Light Water Reactor Sustainability Program

Preliminary Human-System Evaluation of Thermal Power Dispatch Concept of Operations

September 2020

Figure 11. HSI supervisory display depicting the system design and modelling issues reported by the operators and noted by the observation team.

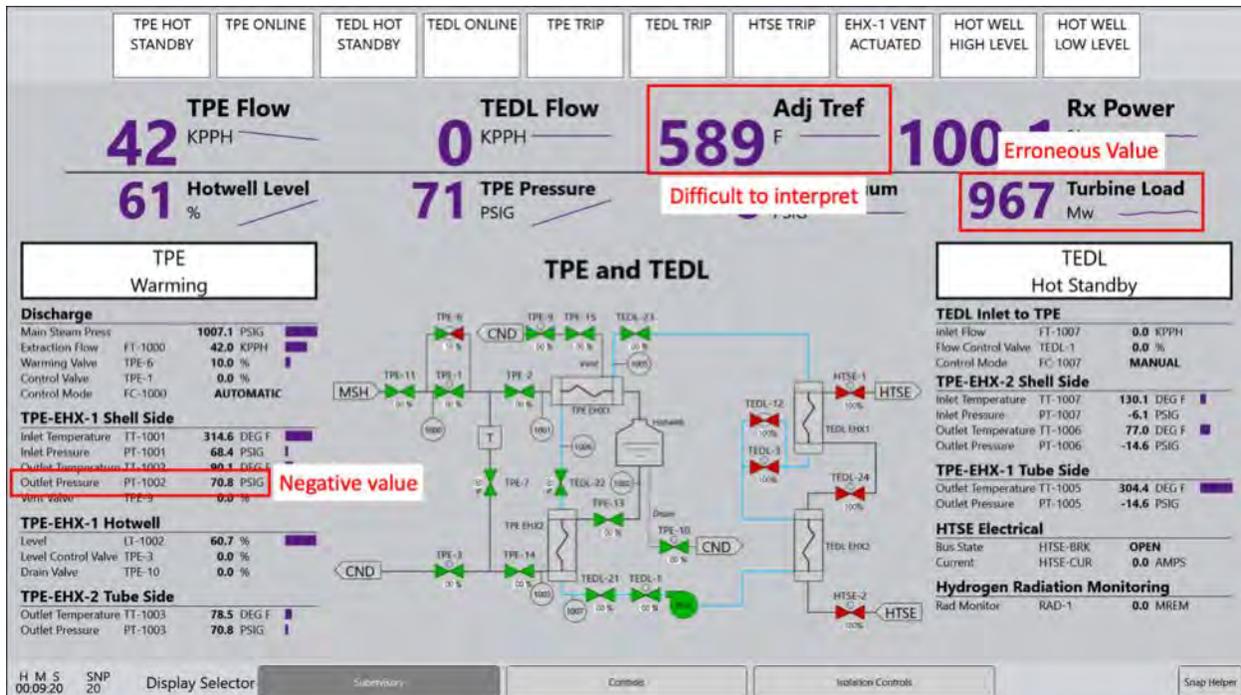
A few key parameters were reported as erroneous values. The turbine load value displayed in the key parameters section was reported as inaccurate by at least one operator in that it was approximately 50 MW higher in magnitude than what was expected by the operator. Several of the operators reported the adjusted Tref parameter was confusing. The adjusted Tref represents the actual Tref with the bias included to prevent the rods from stepping to account for the loss of steam and thermal power due to the operation of the new system. The operators report that the adjusted Tref is not that useful and, instead, they would rather have the bias displayed in conjunction with Tref so that they can see how the new system is affecting larger plant operations.

One operator noted the rad monitor indication in the TEDL data table and questioned how that was used and whether it was necessary. This led to a discussion between the operator and the research team in which the issue of whether a radiation monitor should be placed within the TPE or TEDL or should even be included anywhere in the system. The main steam system already has radiation indicators, and those would be triggered to alert the operator of an issue before any radiation indicator in the thermal and well before any alarm in the electric power dispatch systems would detect the radiation. The question was posed to all operators during the debriefs, and one operator pointed out that even though other indication would be more informative during a radiation event, the addition of radiation indication in the new systems would be useful for cleanup activities after the event. In the end, the decision to include a radiation indication comes down to the cost-benefit tradeoff. It should be noted that no accident or abnormal scenarios were evaluated during this scenario. Thus, the radiation indication was not used in these scenarios. Future expanded testing with abnormal and accident scenarios will inform the decision as to whether radiation indication should be included.

Figure 12. HSI supervisory display depicting the incorrect orientation of the heat exchangers and valve TEDL-24 in the wrong location in the P&ID mimic.

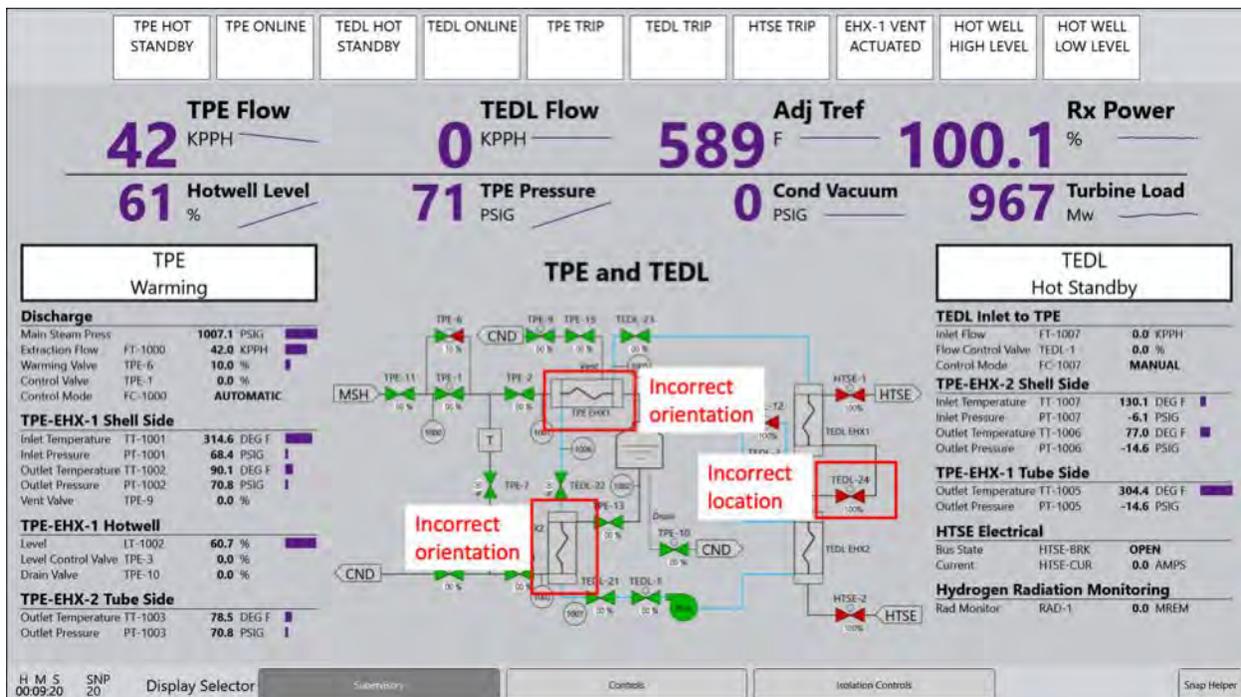
The P&ID mimic was updated to reflect system changes, and one error that was identified was the incorrect location of TEDL-24. More importantly, the incorrect orientation of the TPE heat exchangers was reported. The data tables had the correct relationships, but the graphic was displaying an incorrect relationship between the flow paths in terms of the shell and tube sides of both heat exchangers. Interestingly, this was not discovered until the final operator was run through the scenarios. This highlights the value in having multiple participants during a usability study to ensure the maximum number of issues are identified. Virzi (1992) found that five users can identify 85% of the usability issues within a design. This highlights the diminishing returns from increasing the number of users in usability studies. Considering that this study only employed four participants, it may have yielded less than 85% of the usability issue. However, it is likely that the gross issues were captured, and the remaining undiscovered issues are likely minor. Because the observers also evaluated the interface while the operators performed the scenarios, the argument can be made that there were actually more than five users evaluating the HSI and with reasonable confidence the bulk of the issues were successfully identified. Furthermore, this design is still under development and with additional reviews any lingering usability issues will be identified through the verification and validation approach.

Figure 13. HSI control display showing the ambiguous “Interlock is Armed” status indicator.

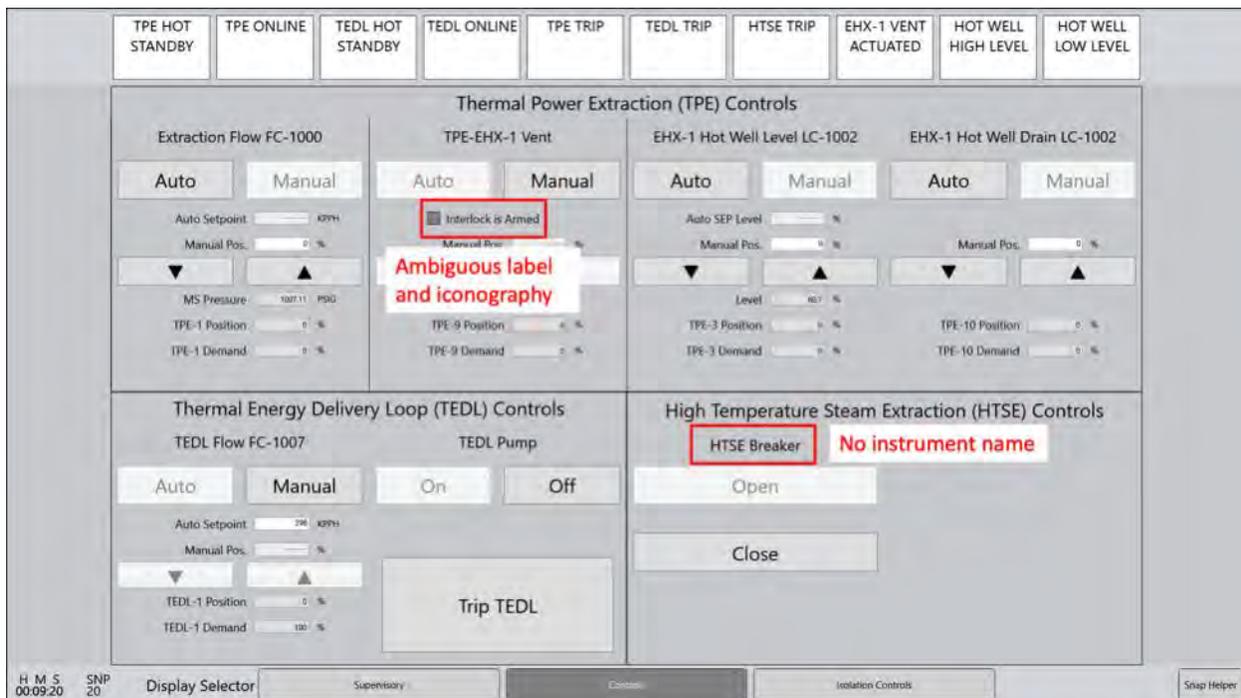
The nomenclature “TPE-EHX-1 Vent Interlock is Armed” was confusing to operators (see Figure 13). The correction for this issue was to remove the interlock terminology and use the auto and manual mode for the vent to denote whether it will trigger at the setpoint value or whether it is controlled manually. This also reduces the iconography required to display the interlock status and eliminates clutter on the display because this is redundant information to the auto and manual state denoted in the controller.

Figure 14. HSI display depicting ambiguous and inconsistent labeling with missing TCS demand and mode indication.

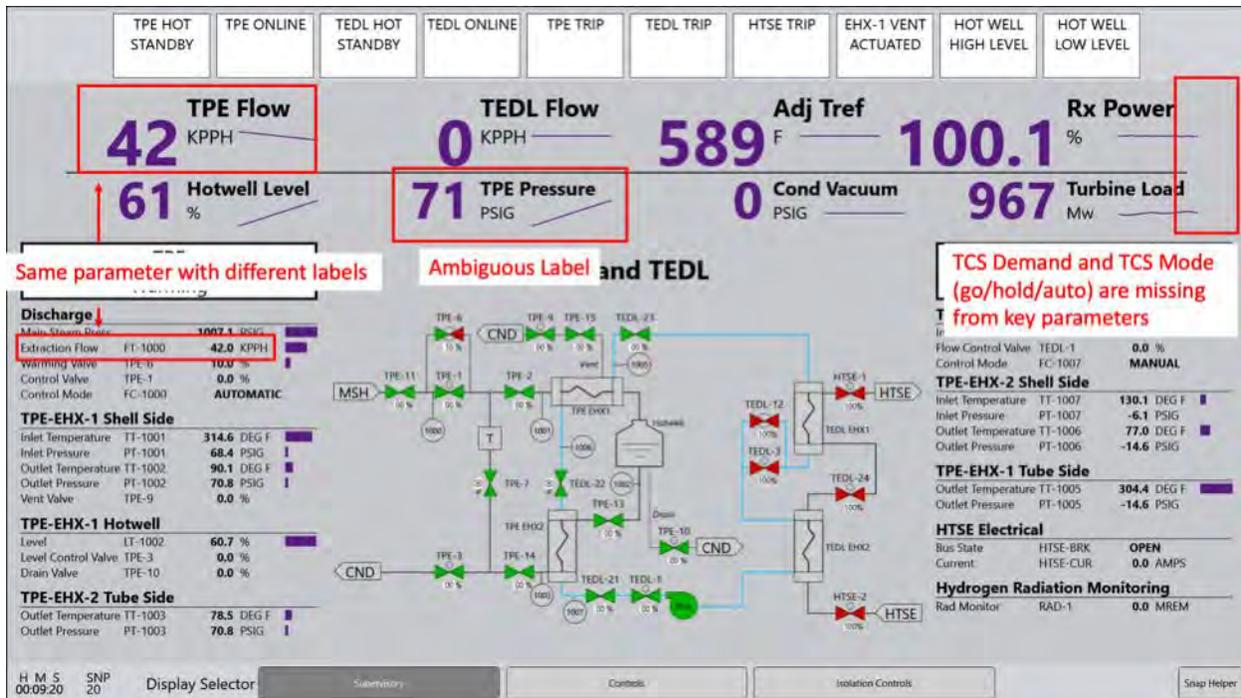
The operators also reported a few issues with the nomenclature of the key parameters section of the HSI supervisory display. The TPE Flow label does not clearly convey where flow is being measured; it should be relabeled to TPE Extraction Flow and should match the data table label as well. The same issue was identified for the TPE Pressure key parameter since it was unclear where in the system this pressure was measured. The label should be revised to TPE-EHX-2 Outlet Pressure to convey its location. Last, the operators requested the inclusion of the turbine status because it is used in tandem with valve manipulations during several of the scenarios evaluated, as can be seen in Figure 14.

Figure 15. HSI depicting the ambiguous correspondence between the valve position in the data table and the valve position as represented in the P&ID mimic.

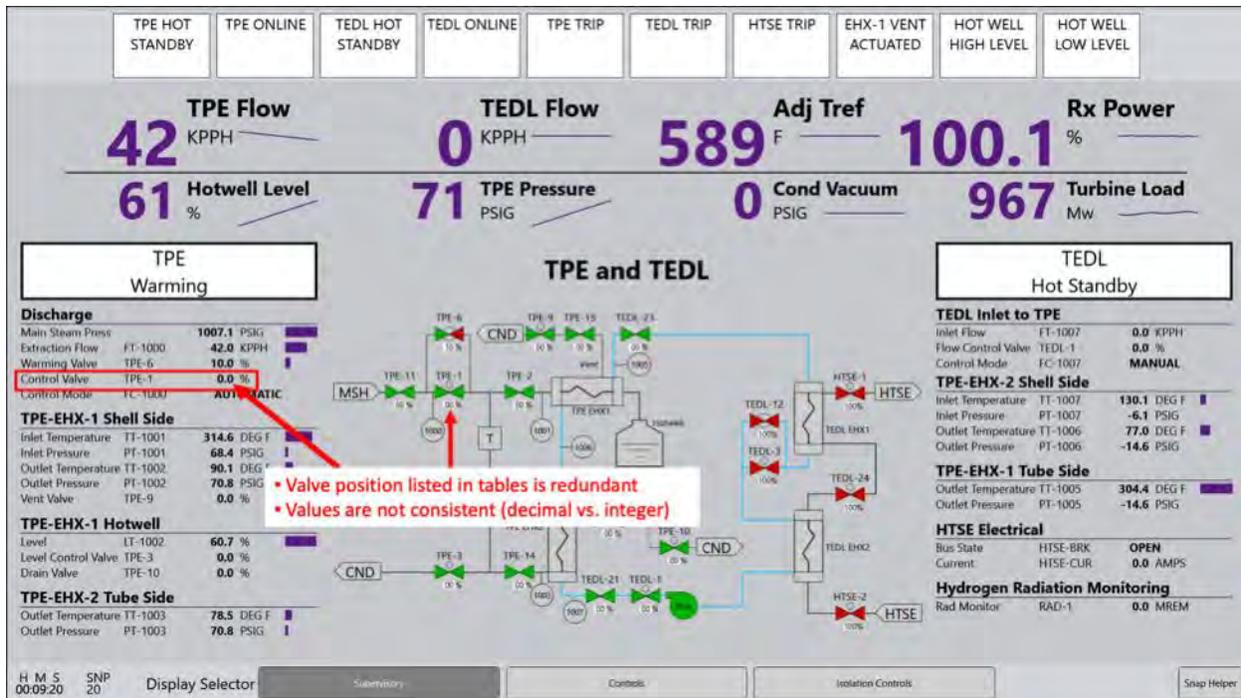
To meet the expectations of the operators and convey information in a manner they are accustomed to, it is important to use consistent styles across display elements of the same type. Consistency should be applied across the interface, and deviations should only be made judiciously. The study identified several issues with consistency. The first issue, as can be seen in Figure 15, pertains to numerical precision consistency for parameters within the display. The data tables contain a single decimal place precision while P&ID mimic valve position indicators have integer percentage precision, and key parameters have integer parameter precision with the exception of Rx Power. As mentioned previously, consistency should be strictly adhered to unless there is a strong reason to deviate from it. In the case of the key parameters, the precision difference was not an issue because these are meant to serve as at-a-glance indicators; therefore, integer precision was adequate. Rx Power is an important key parameter. In particular, having a single decimal value precision is desirable because the plant operates near 100%, but any deviation above 100% is a potentially serious situation. Operators must be aware of the Rx Power to a greater accuracy. The operators were directly asked whether the inconsistent decimal precision was an issue for the key parameters, and none reported an issue with the current configuration.

The data table and P&ID mimic inconsistency were noted by several operators as a source of confusion. The original intent of data tables was to provide an indicative summary of groups of instrumentation depicted on the P&ID mimic. For example, the P&ID mimic depicts the instrumentation associated with the discharge section in the TPE data table with a “1000” in a grey circle. All associated indication for that region of the system are grouped so the operator can identify all parameters quickly in the data table when they are referenced in the procedure. The simulation is calculated and the accuracy that it can provide values is beyond what actual instrumentation might be able to reliably provide. Furthermore, there are some minor changes to these parameters that the decimal level precision is useful for detecting. Unfortunately, the inclusion of valves within the data tables with a different level of precision confused at least two of the operators. One reported that he did not realize the valve represented in the data table was the same as the valve in the P&ID mimic. To alleviate this confusion, the same level of precision should be used for the valves in the data tables and the P&ID mimic. The operators also reported that the valves in an actual plant never provide accuracy beyond 0.5% increments and commonly only provide accuracy to a single percent. Therefore, to maintain consistency throughout the display, all valves will have no decimal place, but rather whole-number percentage level precision.

Figure 16. HSI depicting the dual red and green valve position indication to convey that a valve is in a partial state between fully closed and fully open.

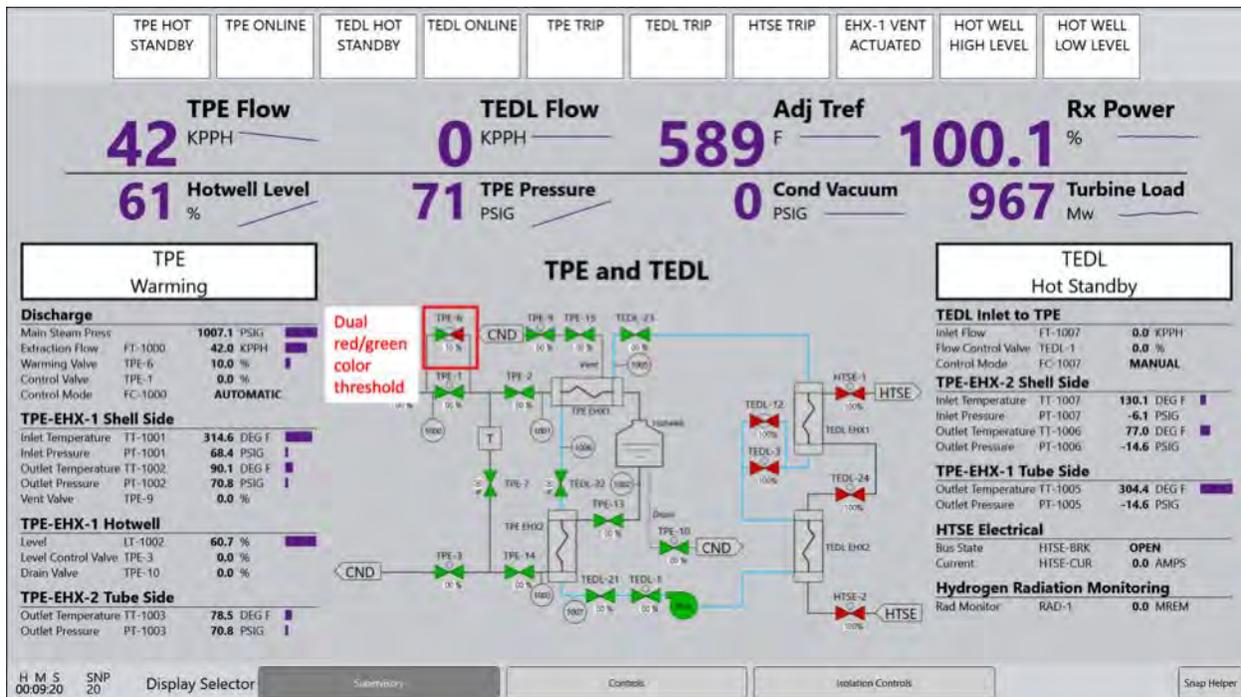
The operators reported no issue with the use of the red and green colors to represent the valve position, with the exception that at least one operator asked what the color coding represented on this display during the discoverability exercise. Once it was explained that green represented closed valves while and red represented open valves, the operators did not report any further difficulty, and no observations were made concerning the operator confusing the states of the valves. Indeed, the red and green color usage is common throughout the nuclear industry, and its application here is consistent with

that usage. During the first scenario, in which the operators were monitoring the interface to observe the use of the TPE-6 bypass valve to warm the TPE system, several operators missed the opening of TPE-6 because the threshold for the dual red and green color coding to indicate partially open (see Figure 16) was set to a threshold of 10% valve position. When asked what the threshold for indicating partially opened at their plants, the operators provided two responses. One noted that the plant they worked at used any registerable reading above zero percent to indicate partially opened. The rest of the operators report that a threshold of 3% or 5% is typical. After debriefing with the operators, a general consensus was formed to use the 3% threshold to show a partial valve position. Interestingly, one operator noted that even with the reduced threshold, the operators shouldn't rely on the dual color change to detect a change in state for the valve, but should independently use the process value and other process parameters to verify the overall process state.

Figure 17. HSI display highlighting the bar graphs used to convey the relative position of each parameter within the data table.

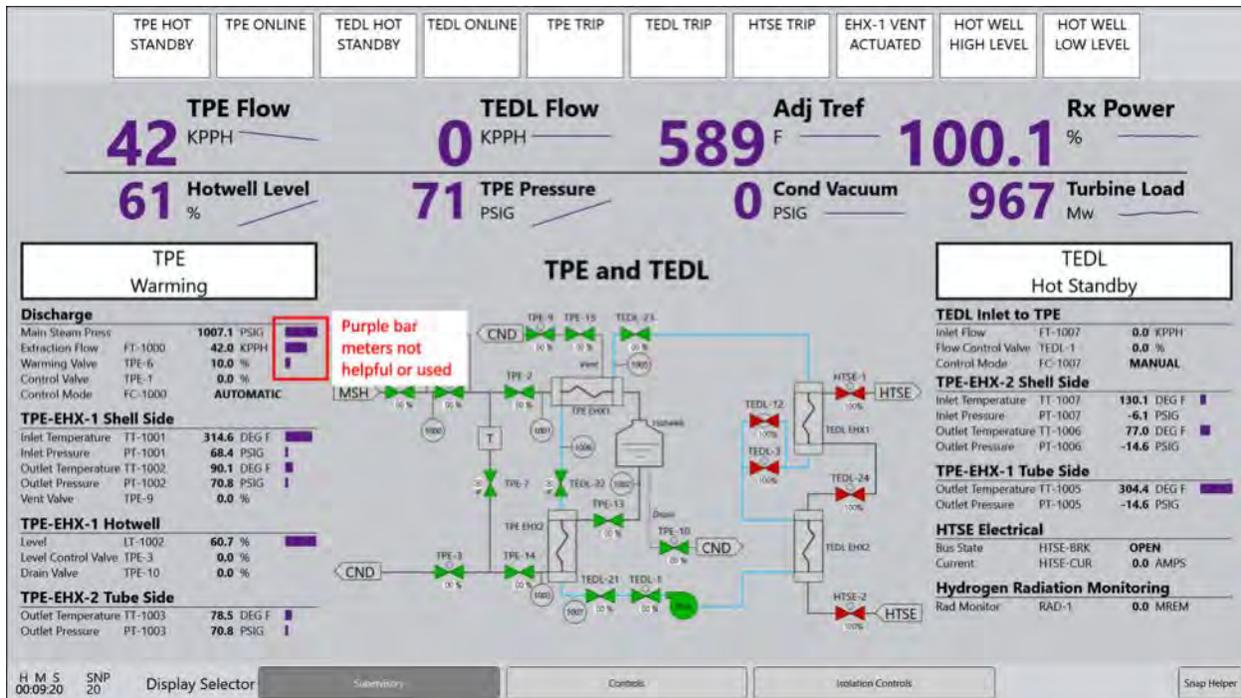
Each of the interval parameters represented in the data table has a bar graph to depict the relative range of the value across the span of a control's operational band. The operators never reported using these, and there were no observed instances of the operators using these during any of the scenarios. The original intent was to create a rapid capability to assess the relative levels of the system and provide emergent features that would allow for at-a-glance identification of system health. However, in practice these bar graphs proved unhelpful and will be removed.

Figure 18. HSI supervisory display depicting the use of sparklines for the key parameters, including along the upper portion of the display.

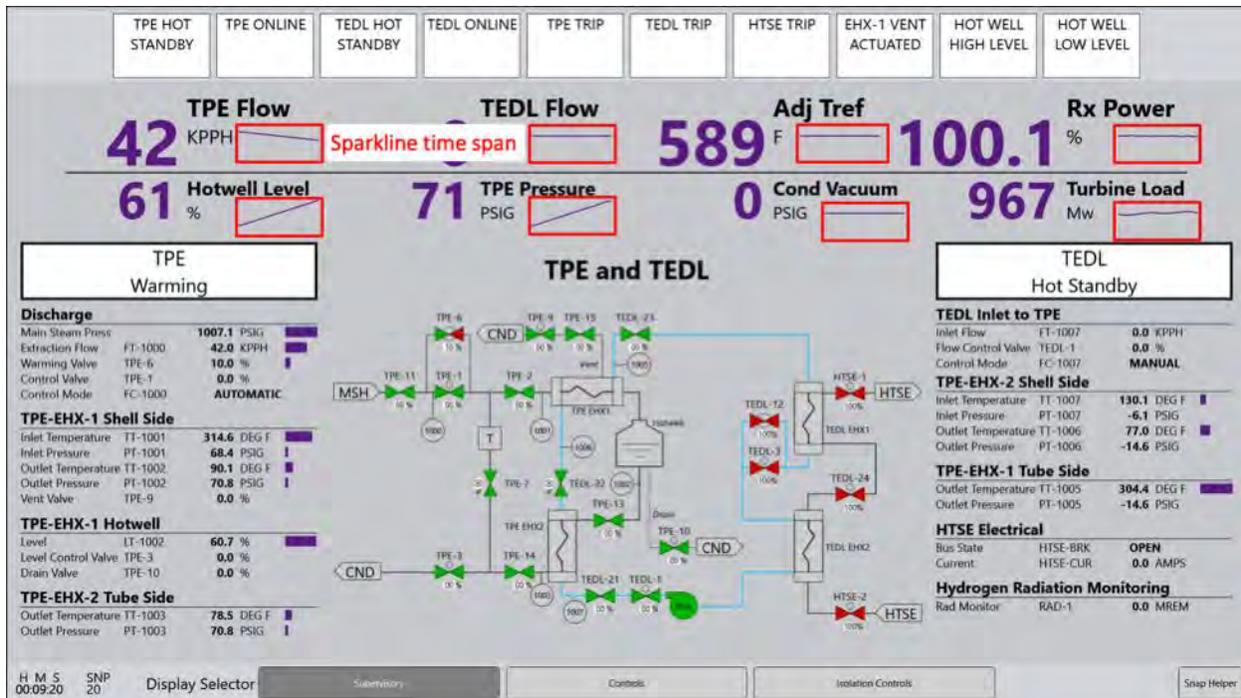
The sparklines used to convey the historical trends for the key parameters was the overall most universally and positively regarded aspect of the HSI design (see Figure 18). The operators noted the trends, and several vocalized their approval of the approach explicitly. The operators were not told what time scale was represented by the sparklines, and when asked, they each reported different time lengths. One operator accurately reported the time span as 20 seconds; another reported the timespan as 2 minutes. The other two reported much larger time spans of 10 and 20 minutes. In all cases, the operators weren't that confident as to the actual time span. This lack of confidence stems from the snapshot nature of the study. After being informed that the actual time span is 20 seconds, all operators reported that the time span should be lengthened, and a general consensus was between 10–20 minutes.

Figure 19. HSI supervisory display depicting the layout of with the P&ID mimic presented prominently in the middle and flanked on either side by data tables of supporting indication.

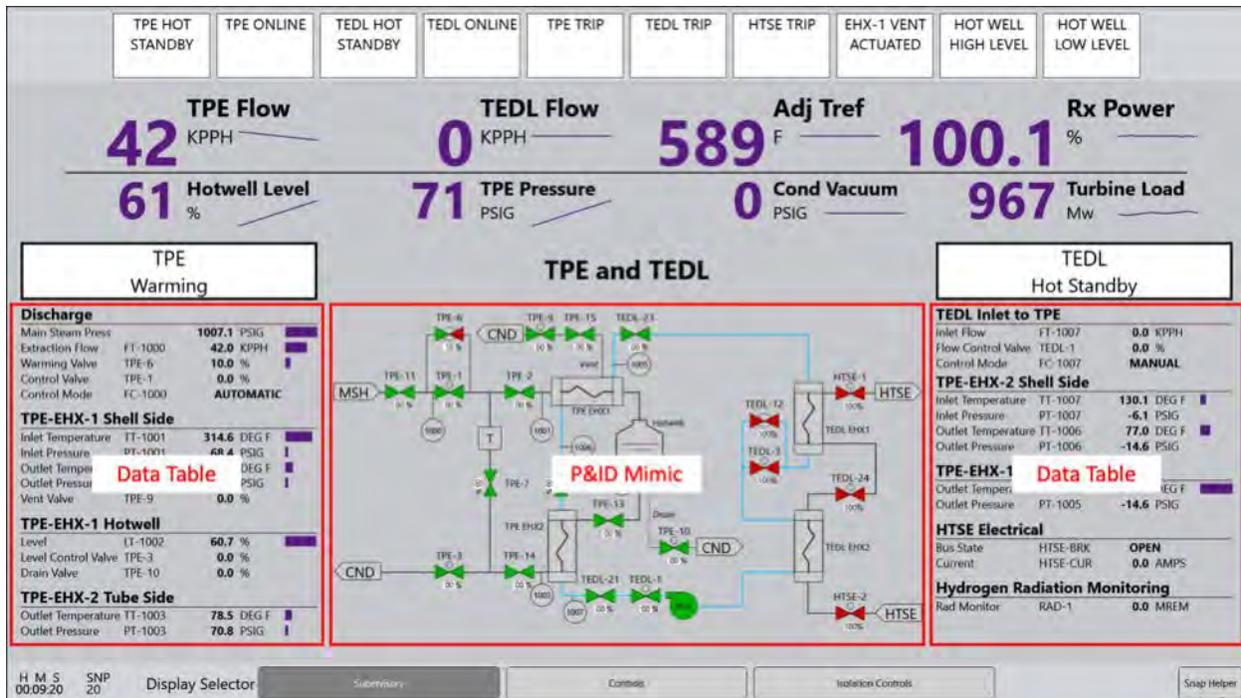
The general structure of the supervisory display included a P&ID mimic in the middle and data tables with supporting indication for the TPE and TEDL systems on each side of the P&ID mimic (see Figure 19). The design was intended to support the operators in using the P&ID mimic to orient themselves grossly within the system, and then they can move to the data tables to find more detailed information concerning the indication positioned near each of the valves and denoted in the P&ID mimic with a grey circle and number associated with the cluster of instruments. In practice, this workflow was not observed. Instead the operators tended to treat the P&ID mimic and data tables as separate entities. Some operators did use the P&ID mimic and data tables as was intended and reported they liked the organization, but others reported it was cumbersome. Additional formats were elicited, with the most advantageous concept being an expanded P&ID mimic with the information embedded in the P&ID itself. This could result in cluttered P&ID in which identifying a specific value becomes challenging; therefore, additional recommendations were made to use a hover-on or click feature in which any element in the P&ID can be selected to display the additional indication. This concept will be explored in future research and iterations of the HSI.
